CITY OF ALBUQUERQUE

November 2, 2022

Re: L & F- Cultivation
4415 Prospect Ave. NE
Traffic Circulation Layout
Engineer's/Architect's Stamp XX-XX-XX (H17-D014)

5 BICYCLE RACK
SCALE: 3/4"=1'-0"

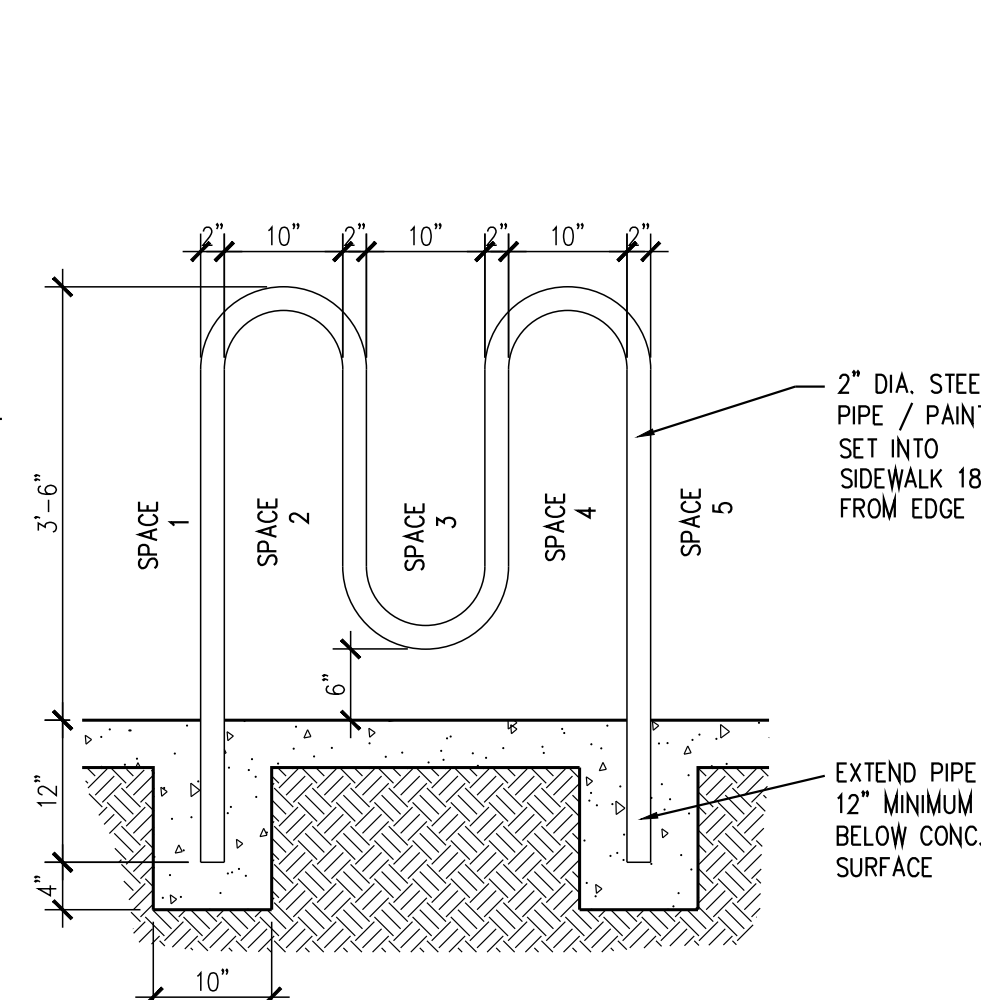
- a. The rack shall be a minimum 30 inches tall and 18 inches wide.
 - b. The bicycle frame shall be supported horizontally at two or more places. Comb/toaster racks are not allowed.

- c. The rack shall be designed to support the bicycle in an upright position. See the IDO for additional information.
 - d. The rack allows varying bicycle frame sizes and styles to be attached.

- e. The user is not required to lift the bicycle onto the bicycle rack.
 - f. Each bicycle parking space is accessible without moving another bicycle.

19. Bicycle racks shall be sturdy and anchored to a concrete pad.
20. A 1-foot clear zone around the bicycle parking stall shall be provided.
21. Bicycle parking spaces shall be at least 6 feet long and 2 feet wide.

6 HANDICAP PARKING SIGN
SCALE: 3/4"=1'-0"

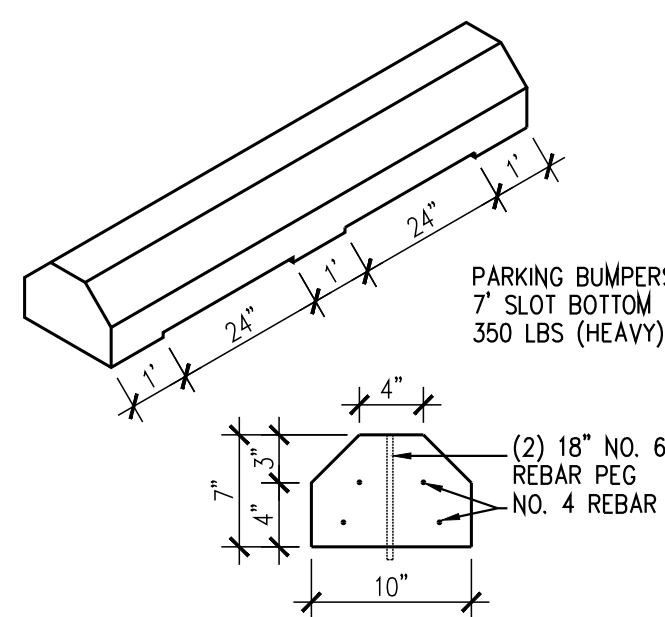
12. The ADA accessible spaces must include an access aisle. Van accessible aisles should be 8ft wide; all others should be 5ft wide.
13. The ADA accessible parking sign must have the required language per 66-7-352.4C NMSA 1978 **"Violators Are Subject to a Fine and/or Towing."** Please call out detail and location of signs.

1 DISABLED PARKING DETAIL
3/16"=1'-0"

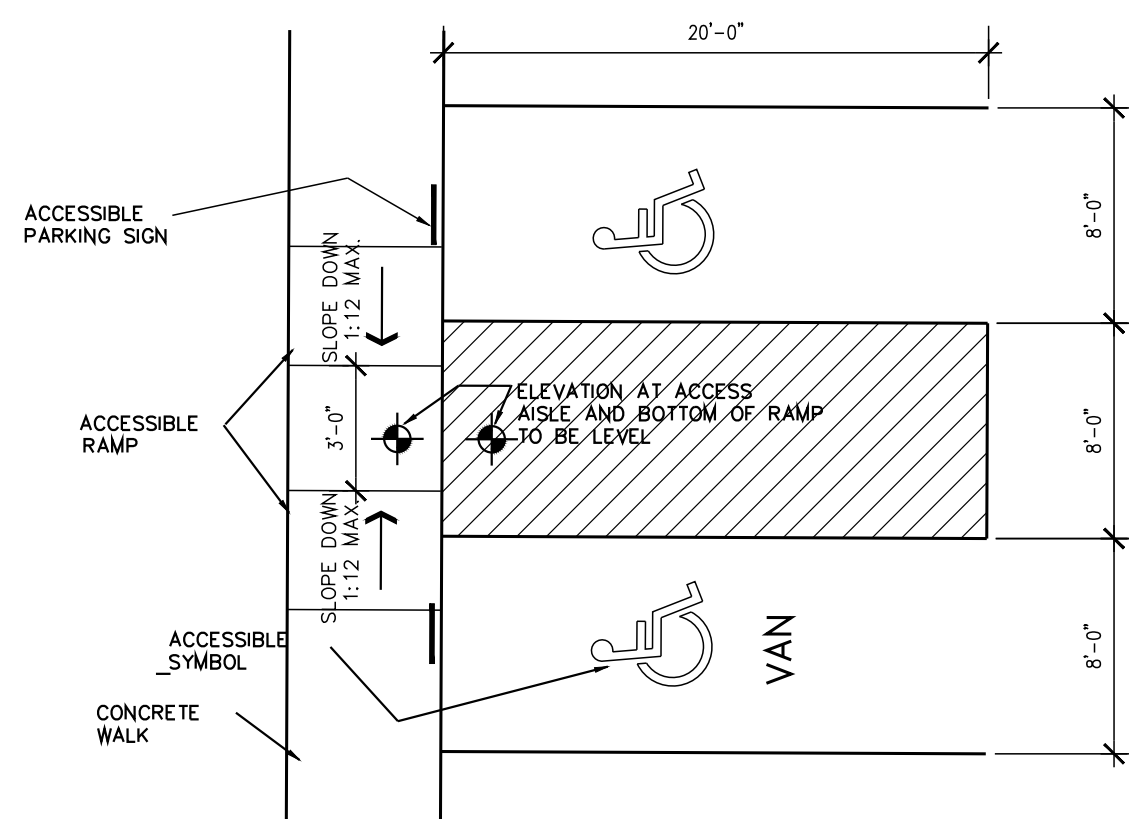
14. The ADA access aisles shall have the words **"NO PARKING"** in capital letters, each of which shall be at least one foot high and at least two inches wide, placed at the rear of the parking space so as to be close to where an adjacent vehicle's rear tire would be placed. (66-1-4.1.B NMSA 1978)

SITE PLAN
SCALE: 1"=20'-0"

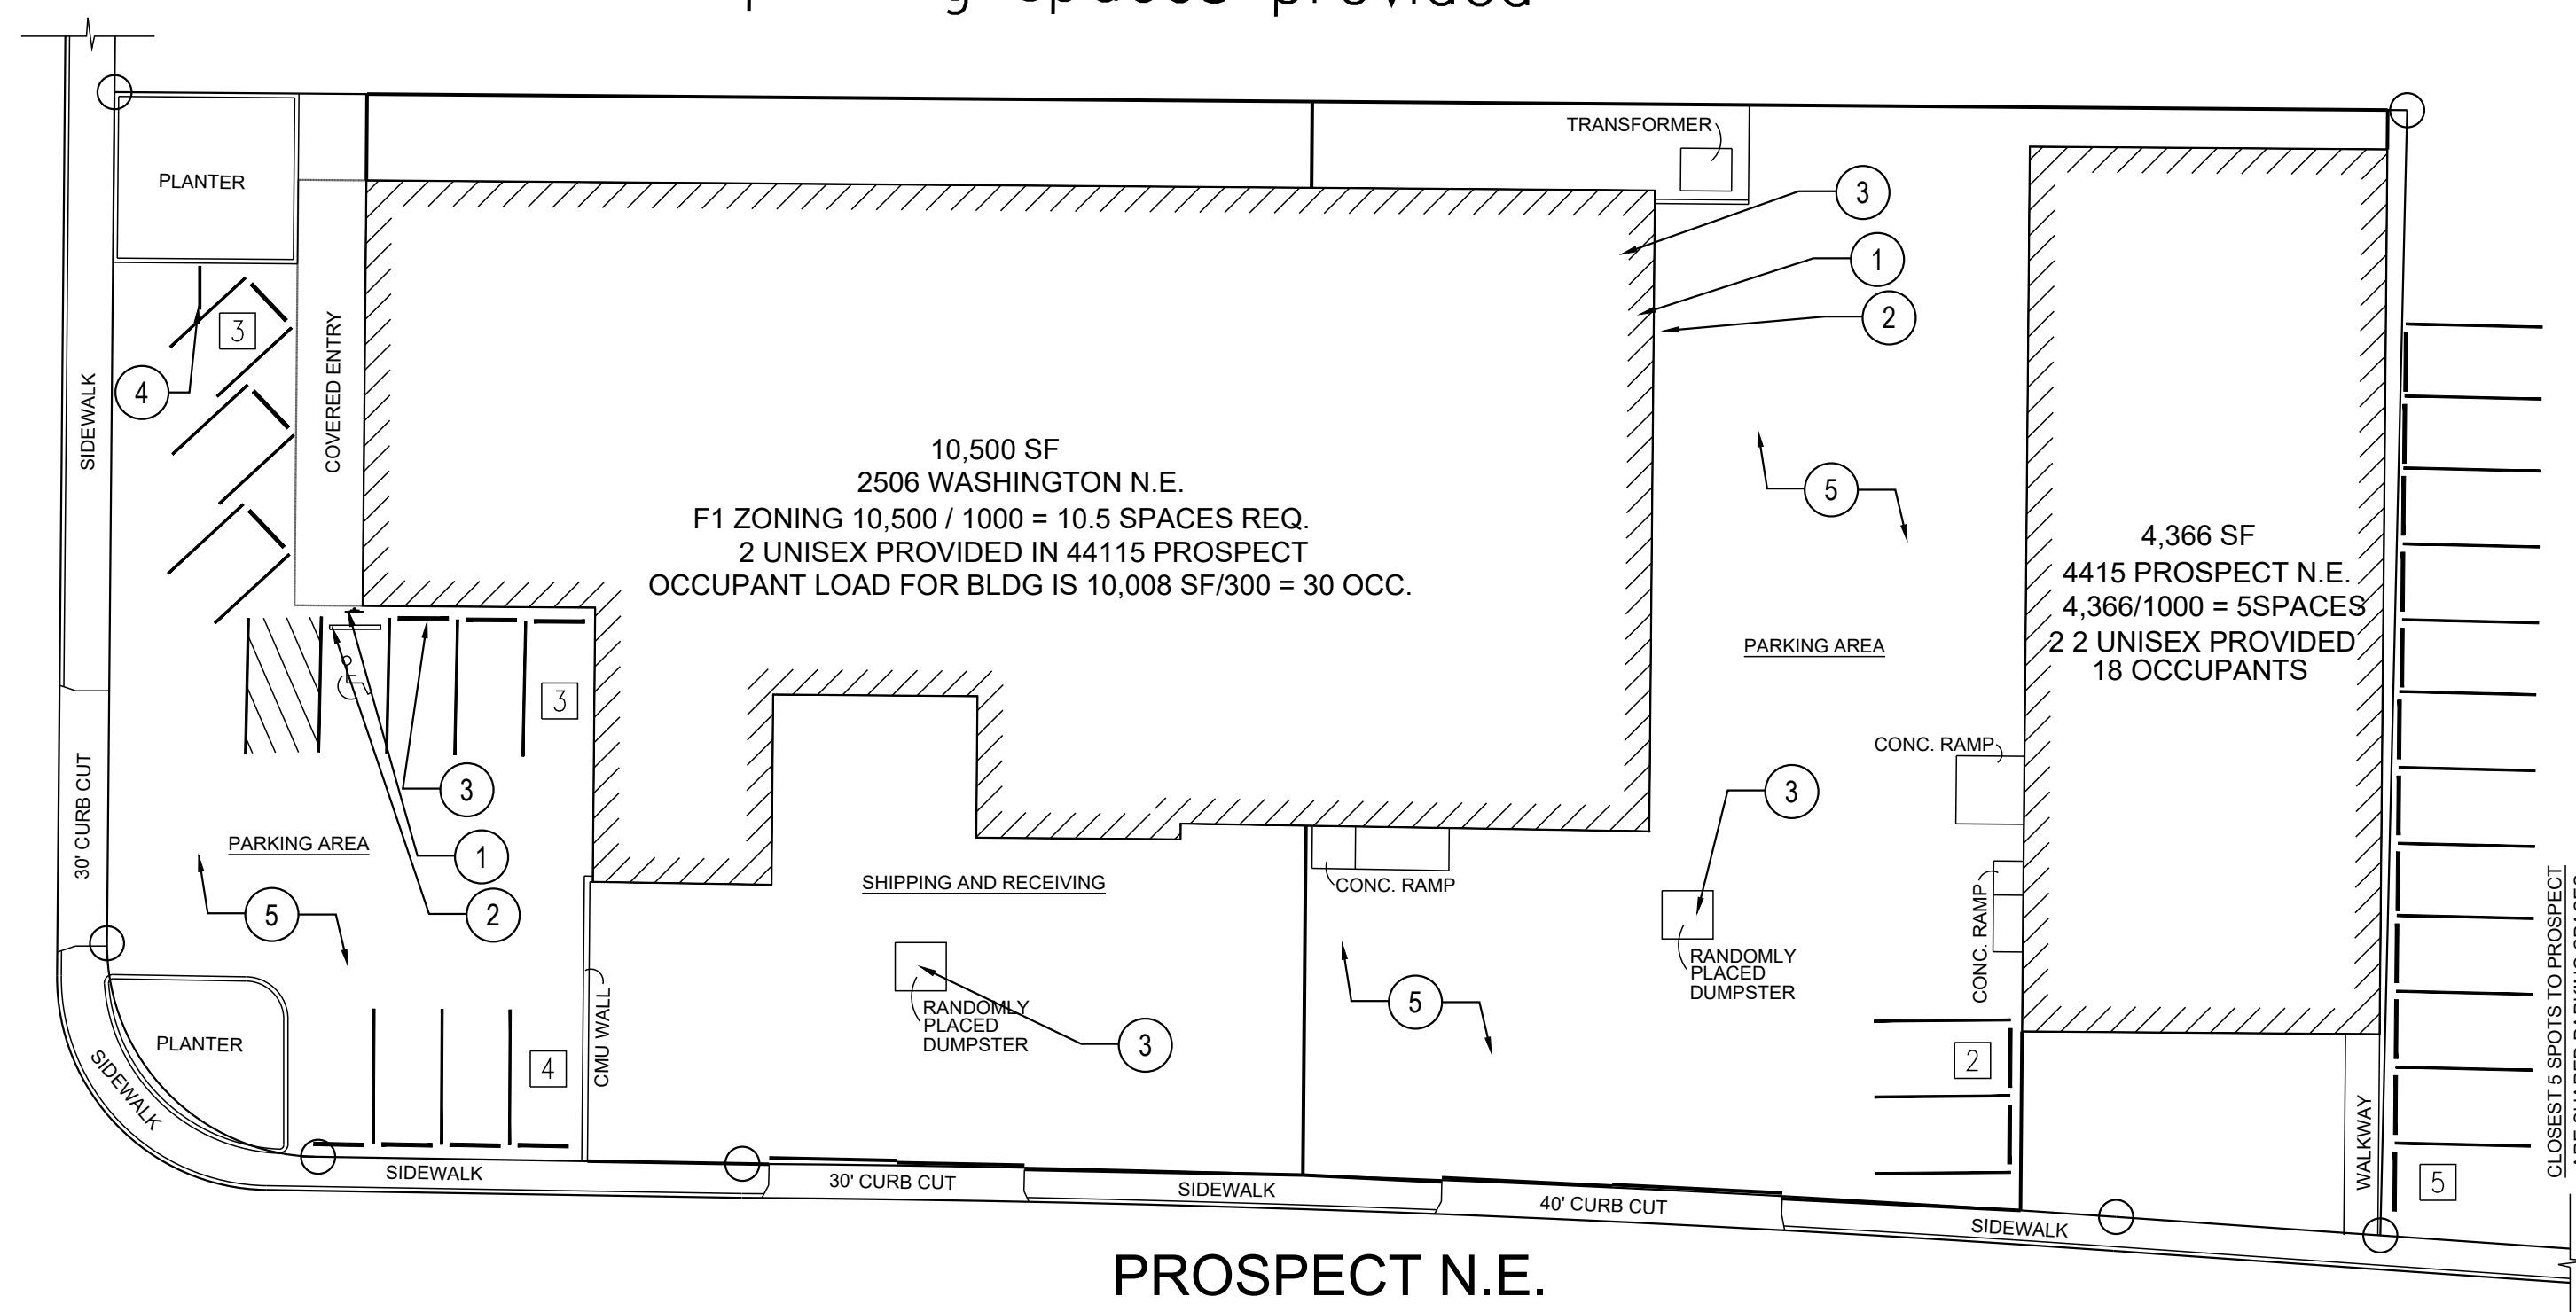
3. The traffic circulation layout must be stamped, signed, and dated by an engineer or architect licensed in the state of New Mexico.
4. Identify the right of way width, medians, curb cuts, and street widths on Washington NE and Prospect Ave NE.

5. Per the DPM (Distance from the Intersection Table), driveway access off Prospect Ave. must be 50 ft away from the intersection of Washington and Prospect Ave. and driveway access off Washington should be 75 ft. away from the intersection. Please clearly show this distance on the site-plan.

8. Provide sidewalk width.
9. Clarify existing property lines and proposed property lines.
10. Please list the width and length for all existing and proposed parking spaces. Some dimensions are not shown.

22. Show all drive aisle widths and radii. Some dimensions are not shown.
23. The minimum drive aisle dimensions are shown below

30. Please provide copy of Fire Marshal approval.
31. Show the clear sight triangle and add the following note to the plan: "Landscaping and signage will not interfere with clear sight requirements. Therefore, signs, walls, trees, and shrubbery between 3 and 8 feet tall (as measured from the gutter pan) will not be acceptable in the clear sight triangle.
